13 October 2021

RE: AMENDMENT REPORT FOR SSD-10224, NEW PRIMARY SCHOOL AT EDMONDSON PARK

Figure 2: Extract of amendment to western elevation (Faulkner Way) (Source: TKD)

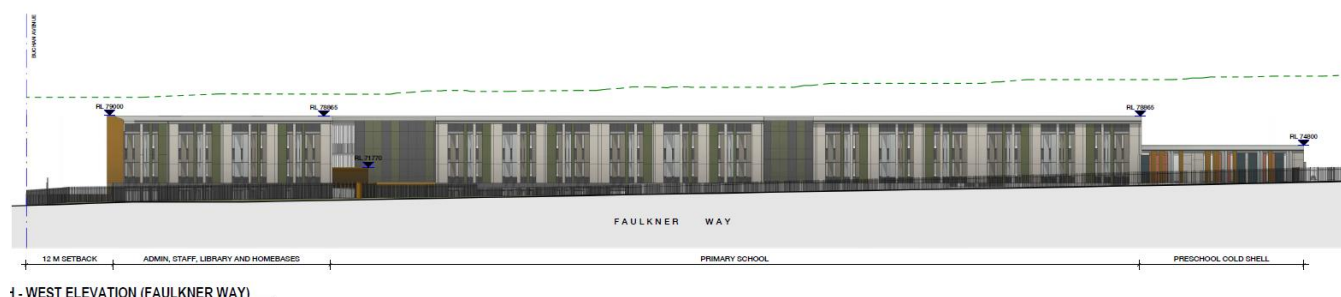
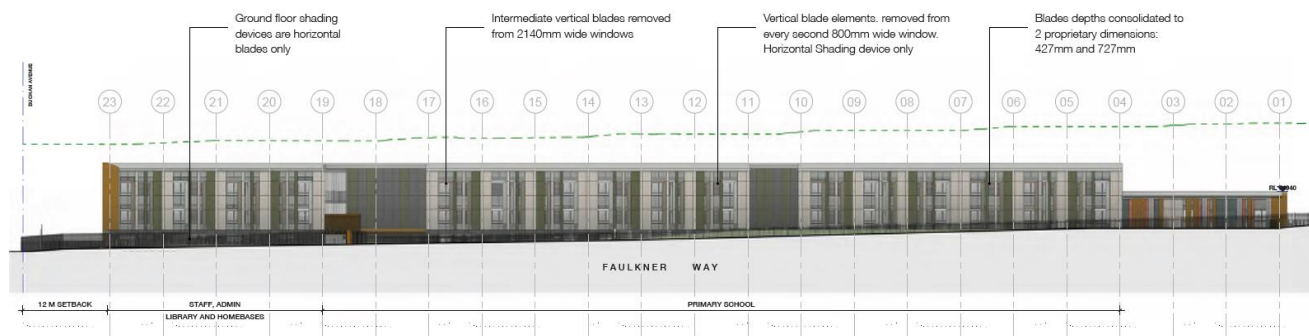
As shown on the Amended Architectural Plans in Appendix 2, SINSW seeks to amend the design of the sun-shades on the western elevation of the Faulkner Way building. The changes involve:

- Ground floor shading devices with horizontal blades only;
- Intermediate vertical blades removed from 2,140mm wide windows;
- Vertical blade elements removed from every second 800mm wide window, providing horizontal shading device only; and
- Blade depths consolidated to two proprietary dimensions – 427mm and 727mm.
